Contract #: 04-0120F4Cty: SF/ALA Rte: 80 PM: 13.2/13.9File #: 69.25B**QUALITY ASSURANCE -- NON-CONFORMANCE REPORT****Location:** Changxing Island, Shanghai, China**Report No:** NCR-000985**Prime Contractor:** American Bridge/Fluor Enterprises, a JV**Date:** 02-Mar-2011**Submitting Contractor:** Zhenhua Port Machinery Company, Ltd (ZPMC), Changxing Island**NCR #:** ZPMC-0943**Type of problem:**

Reference Description: Missed UT Indications Discovered by QA on Lift 14E Vertical Shear Plate to Anchor Plate Weld

Subject: NCR No. ZPMC-0943

Description of Non-Conformance:

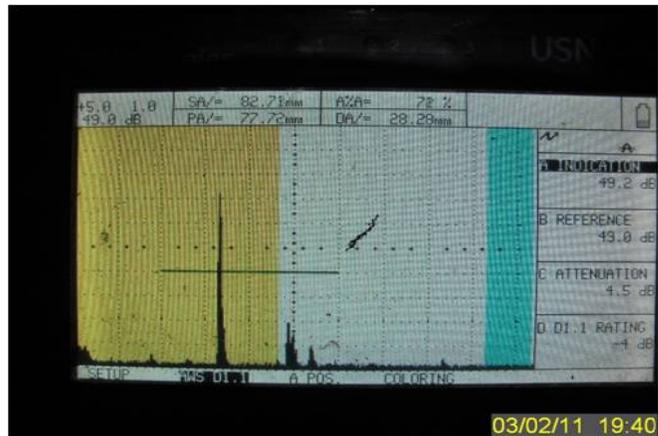
During the Quality Assurance Ultrasonic Testing (UT) review of weld located on Segment 14E, this Quality Assurance Inspector (QA) discovered the following issue:

- A total of two (2) Class "A" rejectable indications measuring approximately 15 and 20mm in length.
- The weld is a Complete Joint Penetration (CJP) Tee Joint, joining the vertical shear plate (SA3364A) to the anchor plate (AP3031A) and is identified as SEG3019BB-157.
- The material thickness is 40mm and the weld is designated as a (FCW) Fracture Critical Weld.
- The depth of the indications are approximately 27 and 29mm.
- The indication db ratings are +3 and -4 respectively.
- The "Y" locations are approximately 1200mm and 1300mm from the termination of the weld at the bottom plate.
- The indication is clearly marked near the weld.
- OBG Segment 14AE located in East Side of fabrication Bay 14.

The Notice of Witness Inspection Number (NWIT) is 08430. The indication is located within the area that has been previously tested and accepted by ZPMC Quality Control (QC) personnel and was found in an area that has been previously rejected and repaired. As per the contract documents, ZPMC's QC personnel are required to perform 100% UT inspection of these welds.

AWS D1.5-2002, Section 6, Table 6.3; “Specifies a class A indication as having a dbS rating of +4 and lower for weld thicknesses 38mm through 60mm.”

Class” A”: Any indication in this category shall be rejected (regardless of length).

Reference Resolution: ZPMC has repaired the indication noted in the NCR and is providing NDT documentation after the repair to show the indication has been removed.

ZPMC has repaired the indication noted in the NCR and is providing NDT documentation after the repair to show the indication has been removed. ABFJV has noted which inspector was responsible for this missed indication and is monitoring his performance, if he continues to miss indications disciplinary action will be undertaken. Based on these actions, ZPMC requests closure of this NCR.

This proposed resolution is acceptable. The documentation received is sufficient and the Department concurs that Non-Conformance ZPMC-0943 is closed.

Description of Non-Conformance:

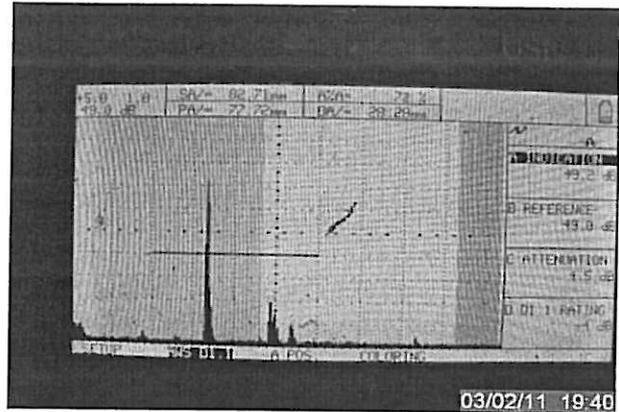
During the Quality Assurance Ultrasonic Testing (UT) review of weld located on Segment 14E, this Quality Assurance Inspector (QA) discovered the following issue:

- A total of two (2) Class "A" rejectable indications measuring approximately 15 and 20mm in length.
- The weld is a Complete Joint Penetration (CJP) Tee Joint, joining the vertical shear plate (SA3364A) to the anchor plate (AP3031A) and is identified as SEG3019BB-157.
- The material thickness is 40mm and the weld is designated as a (FCW) Fracture Critical Weld.
- The depth of the indications are approximately 27 and 29mm.
- The indication db ratings are +3 and -4 respectively.
- The "Y" locations are approximately 1200mm and 1300mm from the termination of the weld at the bottom plate.
- The indication is clearly marked near the weld.
- OBG Segment 14AE located in East Side of fabrication Bay 14.

The Notice of Witness Inspection Number (NWIT) is 08430. The indication is located within the area that has been previously tested and accepted by ZPMC Quality Control (QC) personnel and was found in an area that has been previously rejected and repaired. As per the contract documents, ZPMC's QC personnel are required to perform 100% UT inspection of these welds.

AWS D1.5-2002, Section 6, Table 6.3; "Specifies a class A indication as having a dbS rating of +4 and lower for weld thicknesses 38mm through 60mm."

Class "A": Any indication in this category shall be rejected (regardless of length).

Contractor will repair the weld, and provide the NDT report to prove the weld is acceptable. The performance of the inspector responsible will be monitored and will be disciplined if he is found missing more indications.

Contractor repaired the weld, and NDT report was provided. The NDT report shows the weld is acceptable. The inspector responsible was identified and internal NCR issued.

焊缝返修位置示意图:

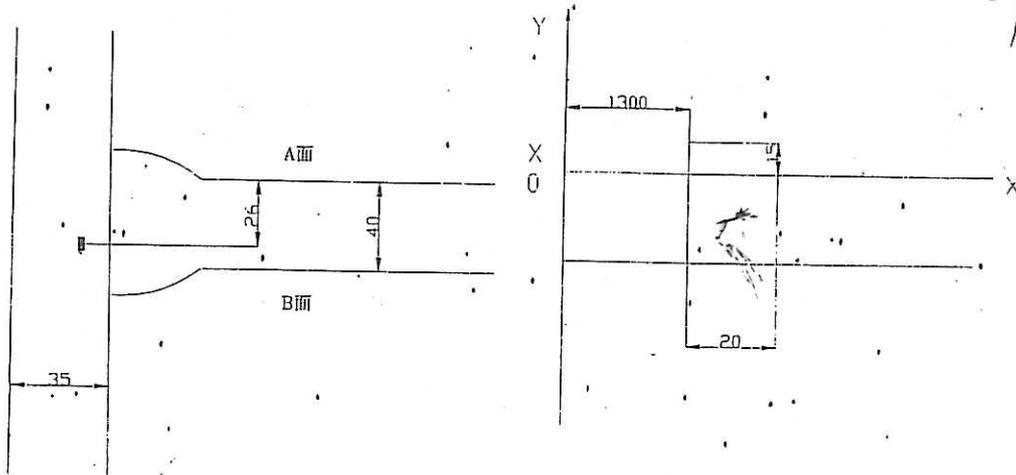
焊缝缺陷描述: (普通UT探伤发现的缺陷长度小于最大允许长度)

(Description of welding discontinuity): Rejected indication found by ultrasonic inspection is less than the maximum allowance aggregate length.

产生原因:

1. 焊道未及时处理干净。
1. Did not clear the weld pass completely in time.

1. 从缺陷距离端面较近一侧 ($D \leq 0.65T$, D为缺陷深度, T为板厚) 采用碳刨或打磨的方法去除焊缝缺陷;
 2. 参照返修焊接工艺规程 (WPS) 准备正确的接头型式, 预热和焊接;
 3. 将修补区域打磨到与母材或邻近焊缝平齐;
 4. 根据批准的车间图纸检查焊缝.
-
1. Gouge or grind from nearer side from metal edge ($D \leq 0.65T$, "D" is depth of defects, "T" is thickness of metal) to remove all defects;
 2. Follow repair WPS for joint preparation, preheat, and weld deposit;
 3. Grind the repaired area flush with base metal or the adjacent weld;
 4. Check the welds according to the working drawings.

1. 加强焊接监控和道间清理。
1. Improve monitoring of welding and interpass cleaning.

外观检查 VT result: √. Acc	检验员 Inspector: <i>Gengwei</i>	日期 Date: 2011-03-12
NDT复检 NDT result: <i>Acc</i>	探伤员 NDT person: <i>Tanyingshan</i>	日期 Date: 2011-03-12
